Sydney Olympic Park New High School

Architectural Response to SDRP Report

Traditional gathering spaces

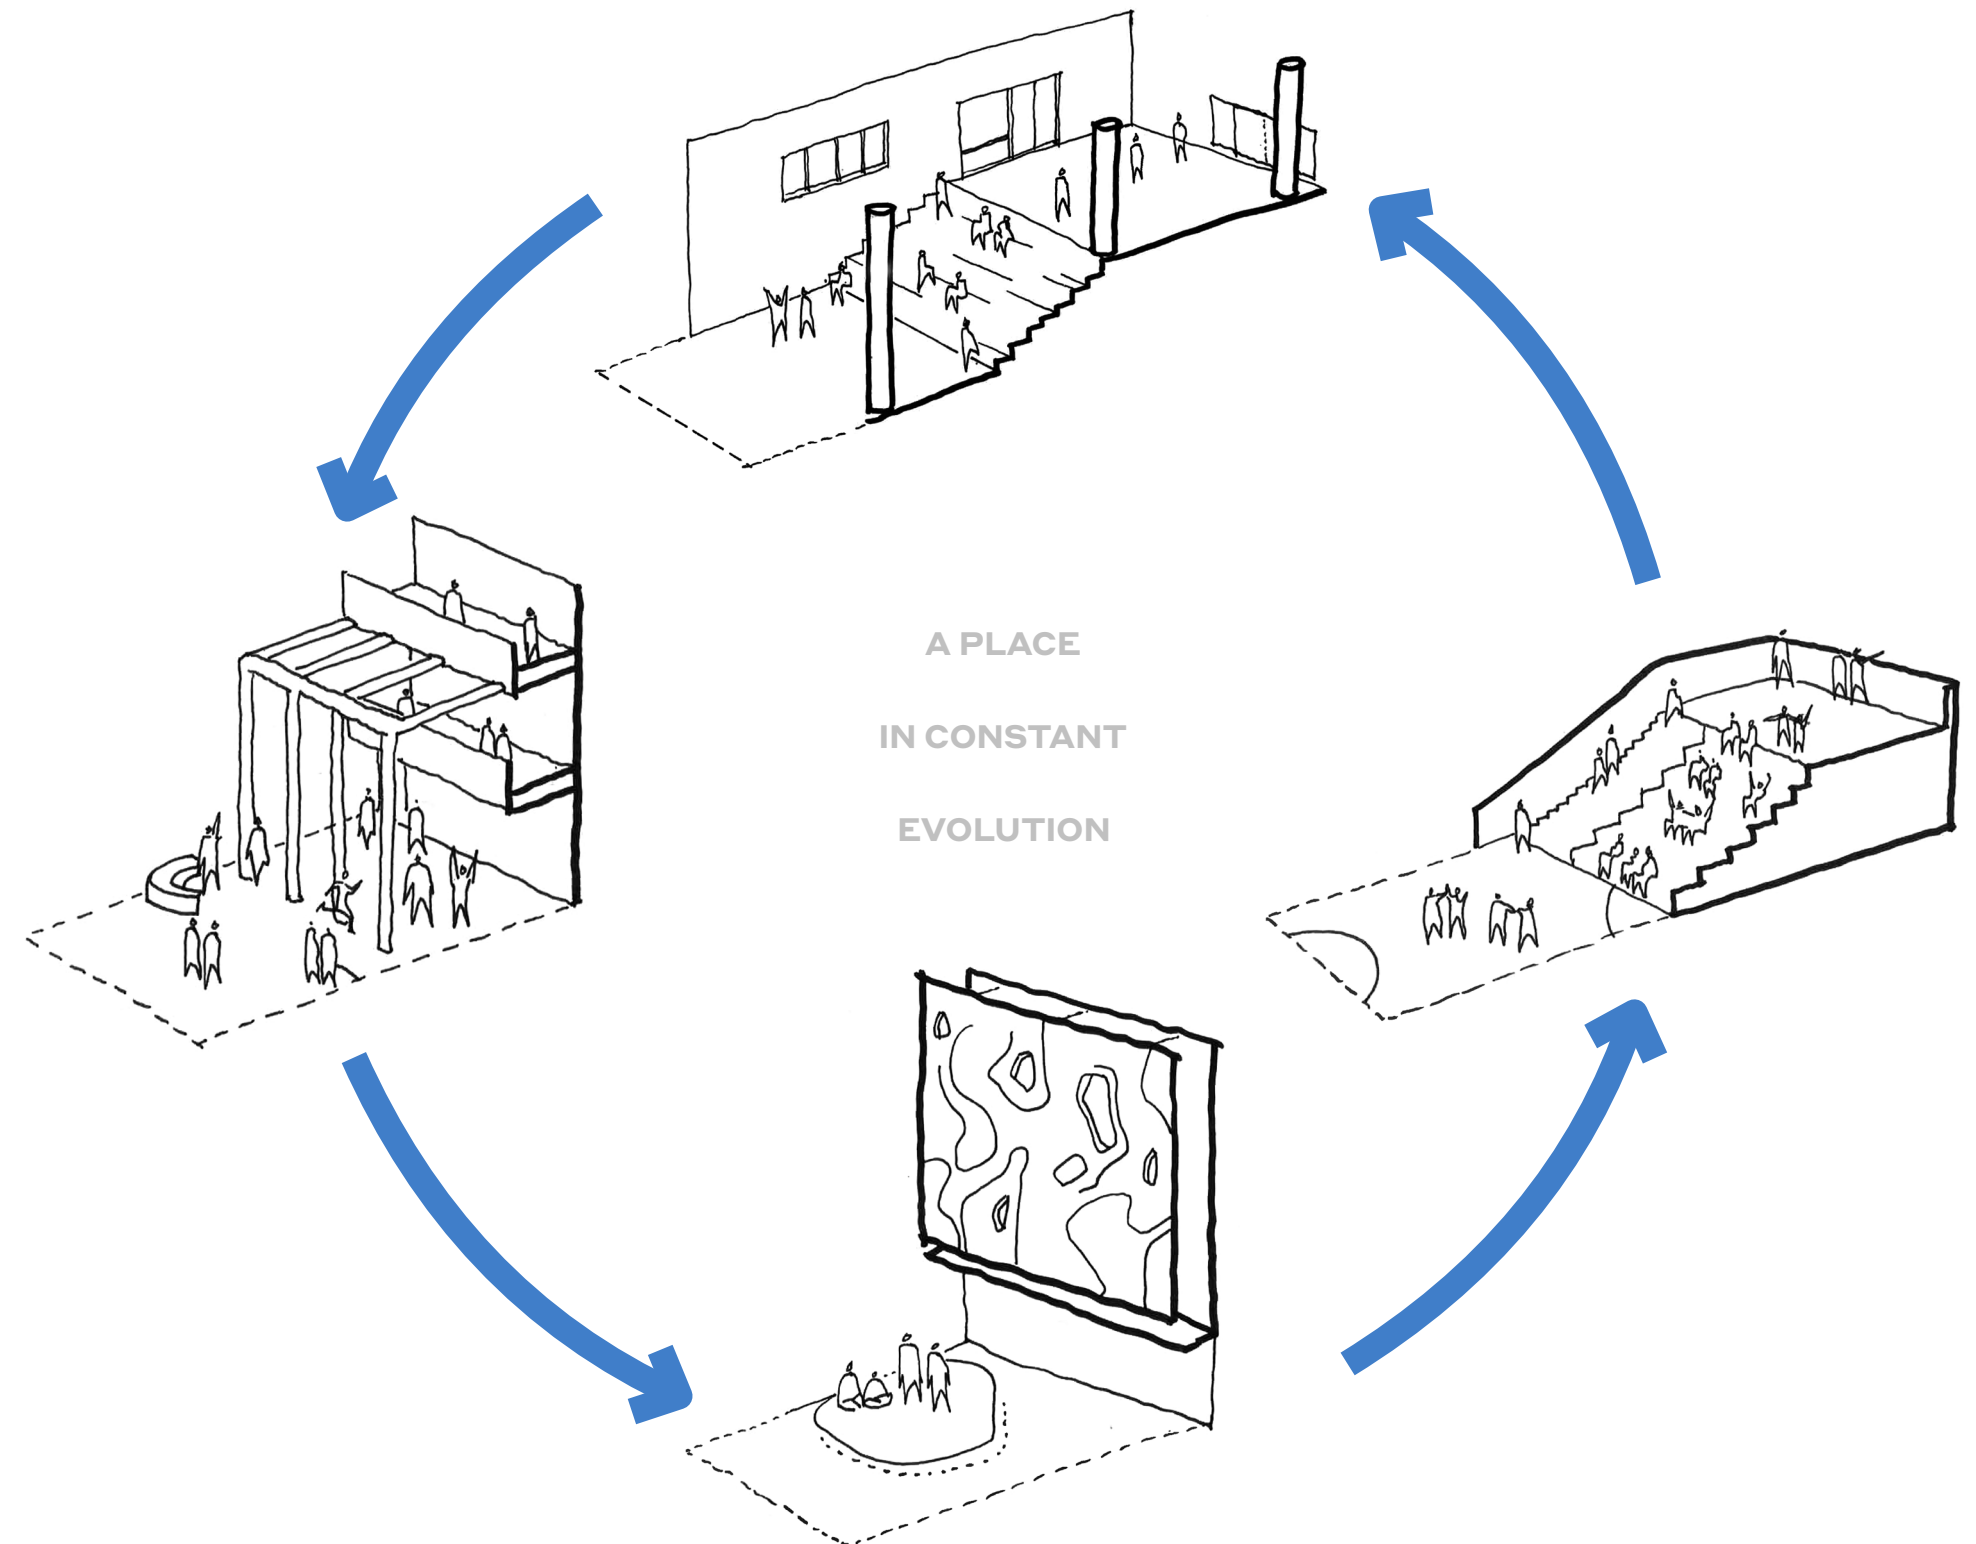
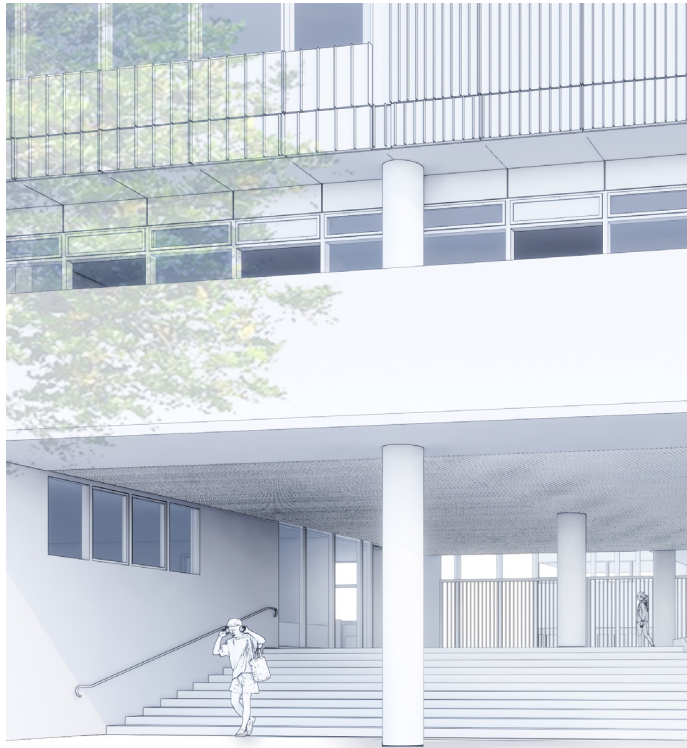
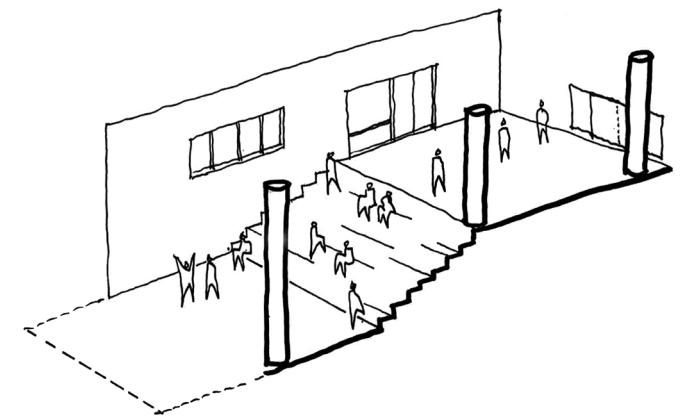
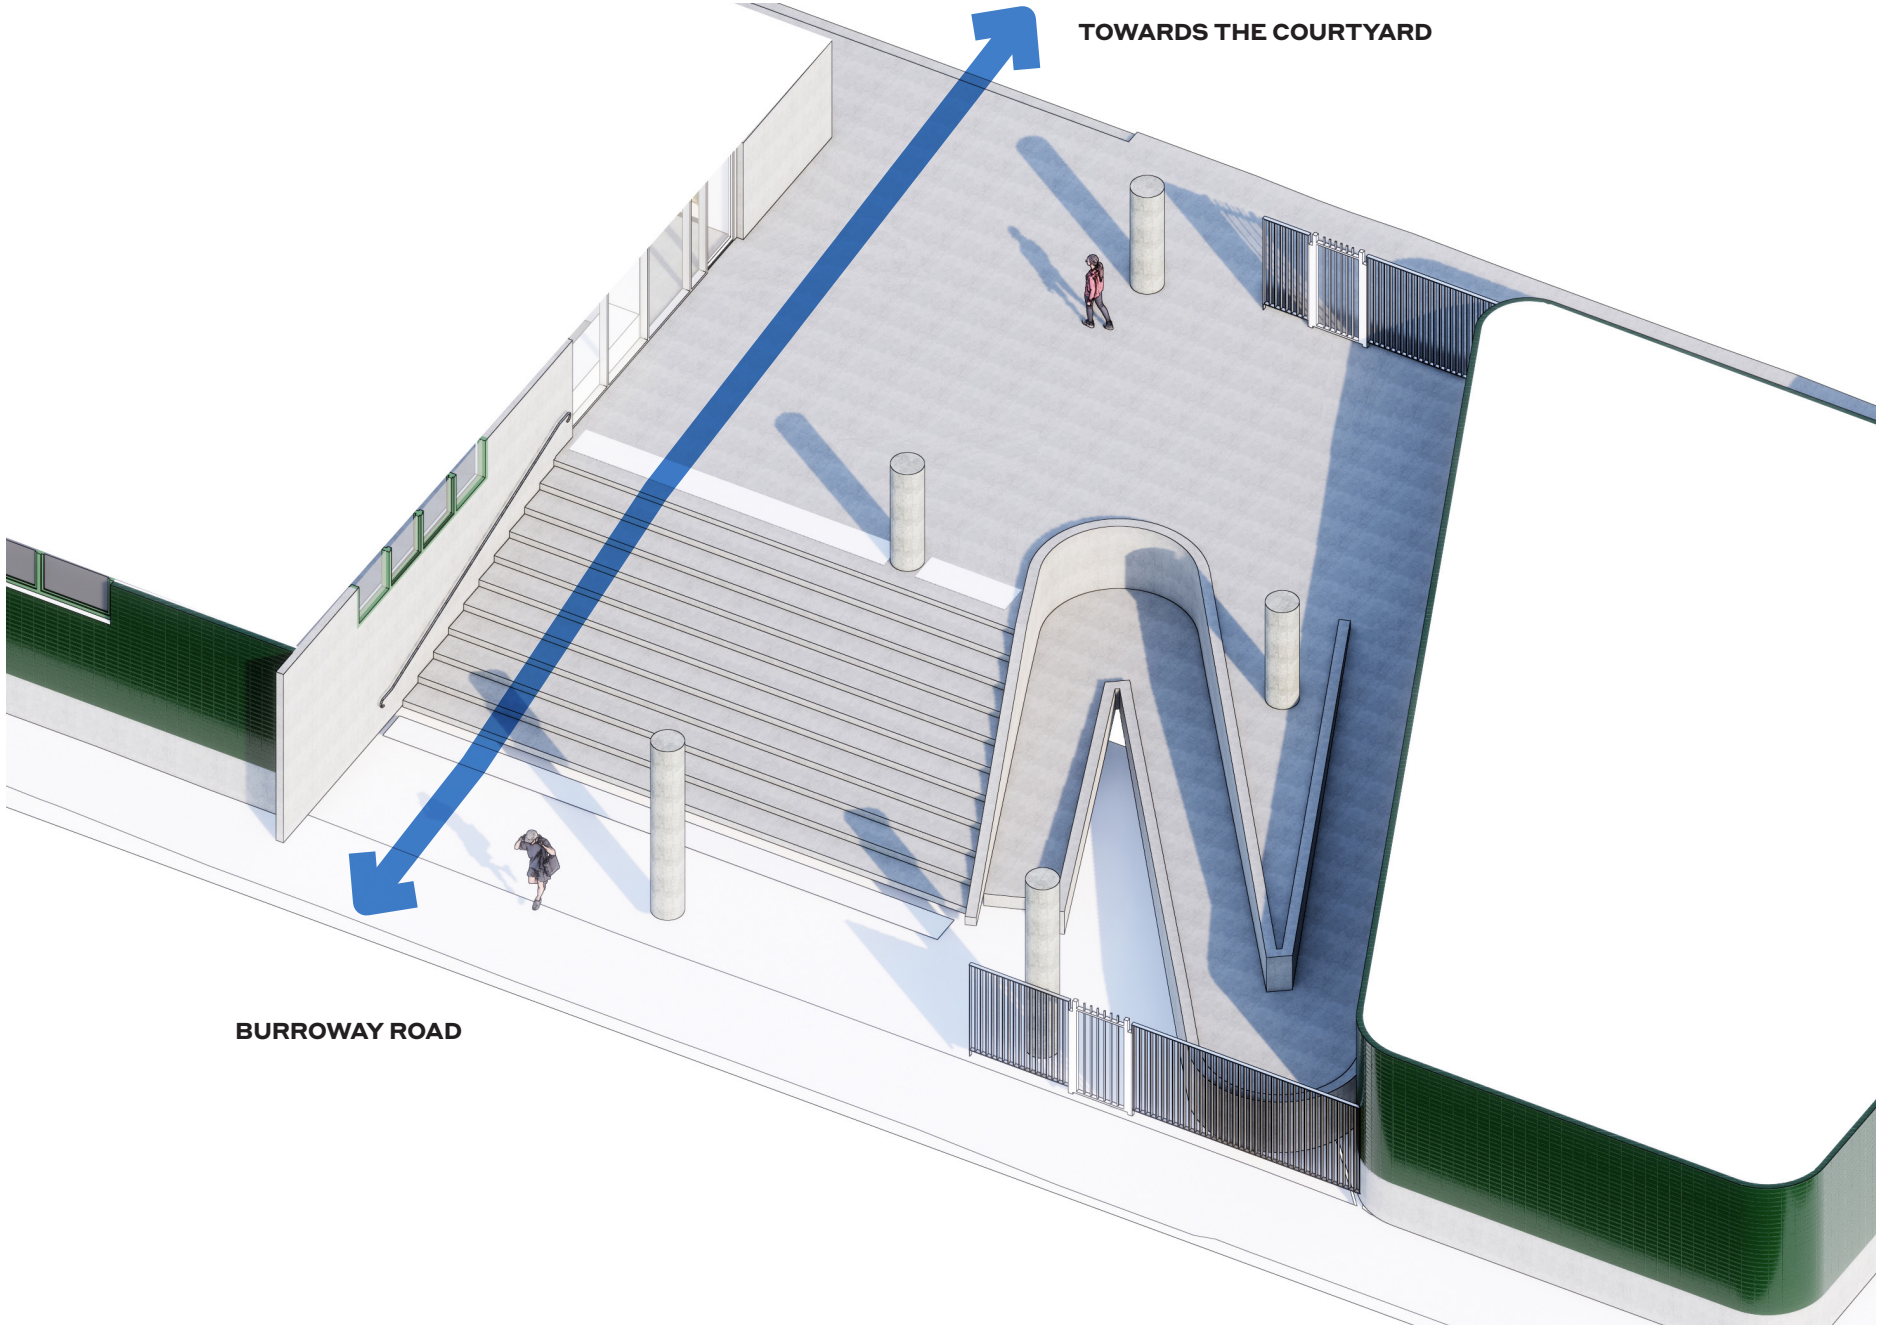
Comment: Traditional gathering places – Elaborate on how Connecting with Country and modes of traditional gathering are referenced in the landscape design.

The design has further developed the identities for the different gathering spaces within the school playground. The evolution of these spaces has focused on achieving a clarity of their scale, character and place within the project's overall narrative of Connecting to Country. Places to gather are now connected as elements within a site-wide tapestry that reflect the undulations of the mudflats that once characterised the site, and the arching, twisting forms of the Parramatta River.

The design approach continues by providing a variety of small, medium and larger spaces, though there is a renewed emphasis on rounded and circular spaces. Like traditional yarning circles, such spaces are inherently democratic and promote the sharing of stories and ideas. The grassed hummocks that define the central courtyard, for instance, have been reduced in size and reconfigured with ovoid geometry, engendering various modes of informal gathering. In addition, the reduction in size of the of the bicycle parking lot has created opportunities for a larger First Nations productive garden. Its geometries are no longer rectilinear and rigid, but sinuous and curving – in tune with the character of the site-wide landscape tapestry.

This overall intent is enhanced by the landscape design which provides a range of small, medium and large gatheric spaces set within local indigenous planting. The planting selection for the site has been chosen to be sensitive of local ecosystems with a majority of species being chosen within local communities including the Sydney Turpentine-Ironbark Forest and Swamp-oak Floodplain Forest that are endemic to the area (refer to planting plans and schedule which highlight native and endemic plant species).

Planting within the view corridor

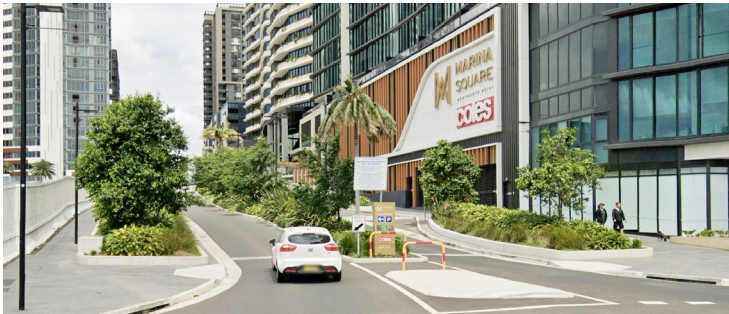
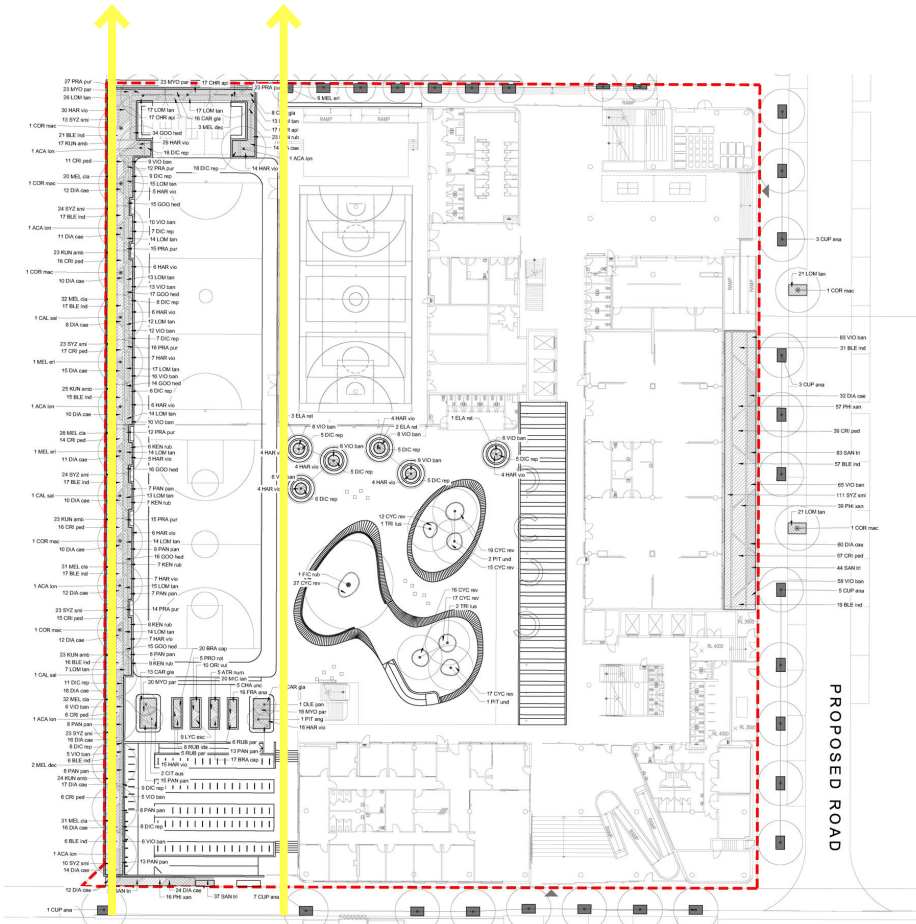
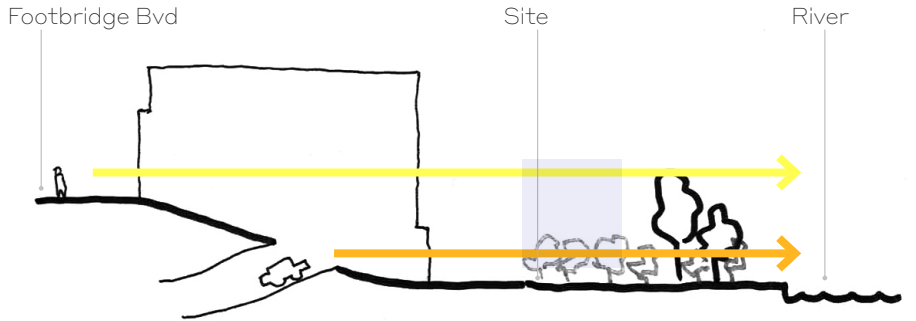
Comment: View corridor – Demonstrate that the proposed planting will not interrupt the view corridor along the western boundary.

The view corridor that continues the alignment of Wentworth Place is not a current planning control – it is an artefact of an earlier precinct masterplan involving a roadway in this zone. As such, there is no formal requirement to maintain an unobstructed view across to the parklands. It should be noted the school ground is at a different level to the footpath along Burroway Rd in order to accommodate the capping and compaction layer.

Regardless, the design team has chosen to avoid placing any built form along the ~23m wide zone against the western boundary. In addition, the planting strategy seeks to frame the western boundary with taller planting and proposed planting along the street frontage is to be low lying shrubs that do not obstruct the view into the site.

The true view towards the river is achieved from the highest level along Wentworth Place.

View towards the river is achieved from the highest level of Wentworth Place. Therefore, no pedestrian visibility to the river will be affected by the proposed planting nor the building .

The new planting along the western boundary as well as the main building will not block the existing view.

Item E4 Soft landscaping

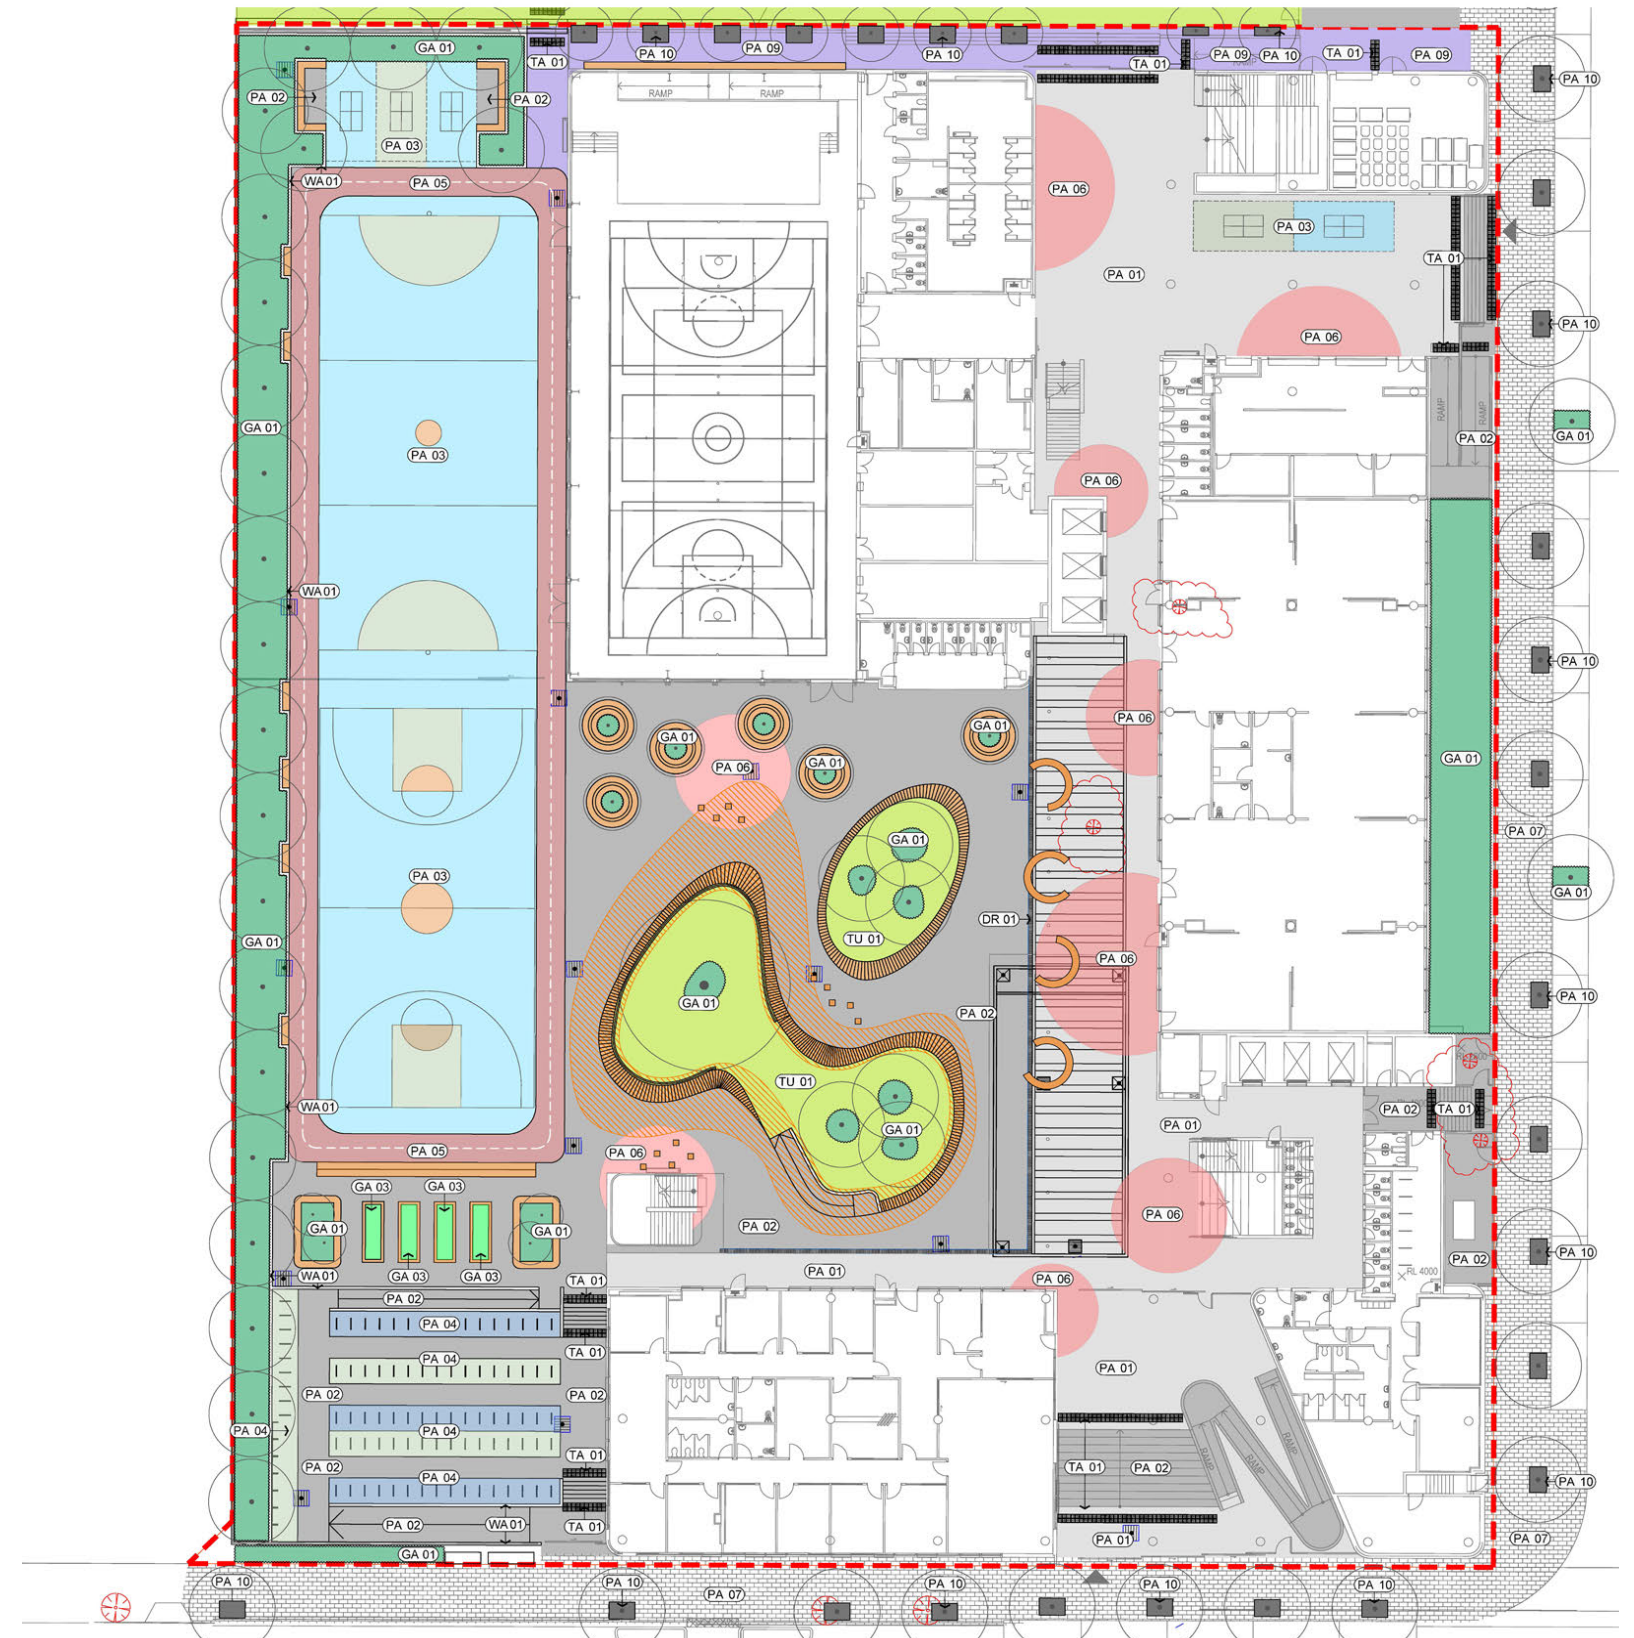
Comment: Soft landscape – Review the areas of soft landscape to ensure the appropriate balance between green amenity and gathering spaces, particularly in the central courtyard.

Additional canopy trees have been added along the northern and western boundary. The central courtyard design has been refined, the raised lawn platform footprints have been reduced to provide additional paved areas for circulation and gathering.

The current raised lawn areas provide adequate soil depth and volume for the proposed small and large canopy trees above the capping layer.
